ULNRC-05281

**DOCKET NUMBER 50-483  
CALLAWAY PLANT  
UNION ELECTRIC CO.  
APPLICATION FOR AMENDMENT TO  
FACILITY OPERATING LICENSE NPF-30  
ADOPTION OF INDUSTRY TRAVELER TSTF-490**

AmerenUE herewith transmits an application for amendment to Facility Operating License Number NPF-30 for the Callaway Plant. The proposed license amendment request (LAR) would revise Technical Specification (TS) 1.1, "Definitions," and TS 3.4.16, "RCS Specific Activity."

~~Figure 3.4.16-1 (page 1 of 1)~~  
~~Reactor Coolant DOSE EQUIVALENT I-131 Specific Activity~~  
~~Limit Versus Percent of RATED THERMAL POWER~~

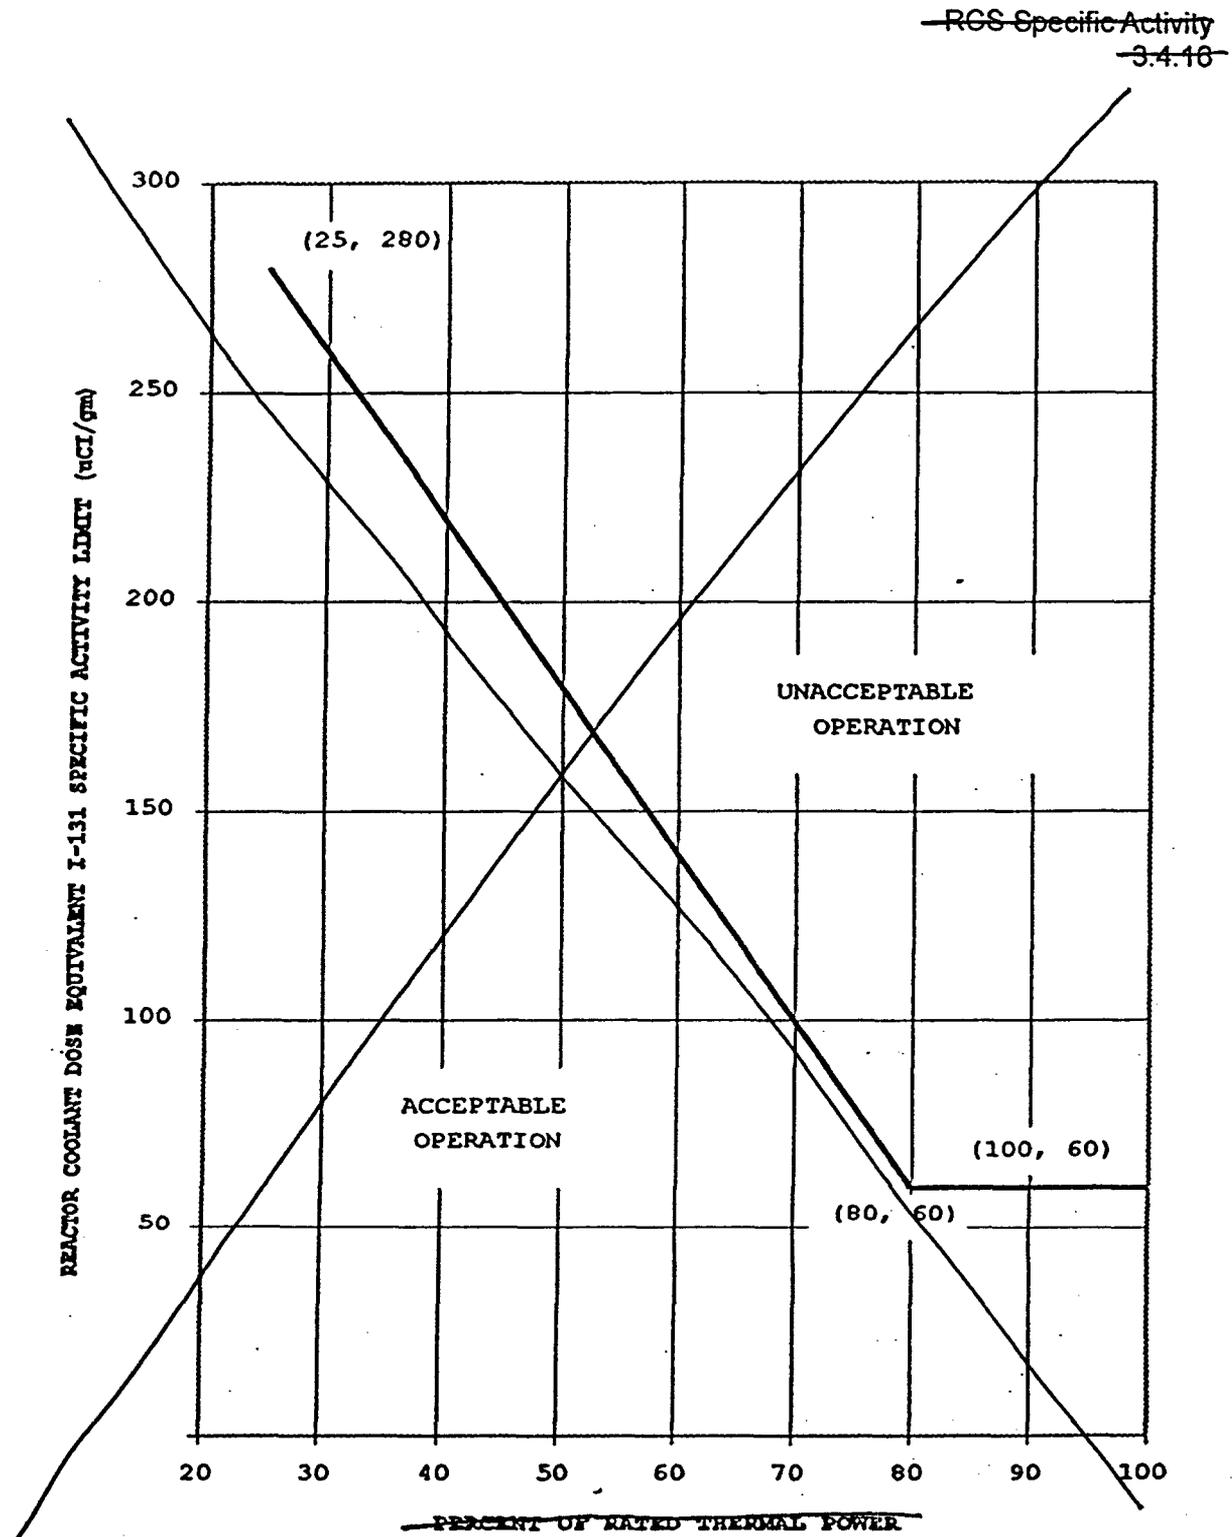
The current TS Figure 3.4.16-1, "Reactor Coolant DOSE EQUIVALENT I-131 Specific Activity Limit Versus Percent of RATED THERMAL POWER" would be deleted.

TS 3.4.16 Required Action A.1 is modified to remove the reference to Figure 3.4.16-1 and insert a limit of less than or equal to  $60$   $\mu\text{Ci/gm}$  for DEI.

The curve contained in Figure 3.4.16-1 was initiated by the AEC in a June 12, 1974 letter from the AEC on the subject, "Proposed Standard Technical Specifications for Primary Coolant Activity." However, this letter does not provide any technical basis for the curve.

The Case 2 radiological consequence analyses for SGTR and MSLB accidents that take into account the pre-accident iodine spike do not consider the elevated RCS iodine specific activities permitted by current TS Figure 3.4.16-1 for operation at power levels below 80% RTP (i.e. DEI of 60  $\mu\text{Ci/gm}$  at 80% RTP increasing linearly to [225]  $\mu\text{Ci/gm}$  at [25%] RTP). Instead, the Case 2 analyses assume a DEI concentration 60 times higher than the corresponding accident's Case 1 analysis assumption [which corresponds to the 60  $\mu\text{Ci/gm}$  specific activity limit associated with 100% RTP operation as discussed in Section 3.1 above]. Therefore, TS 3.4.16 Required Action A.1 should be based on a limit of 60  $\mu\text{Ci/gm}$  to be consistent with the assumptions contained in the radiological consequence analyses. It is not expected that plant operation at reduced power levels would result in iodine specific activity levels that exceed the 60  $\mu\text{Ci/gm}$  upper limit defined for full power operation.

"Verify DOSE EQUIVALENT I-131  $\leq 60 \mu\text{Ci/gm}$ ."
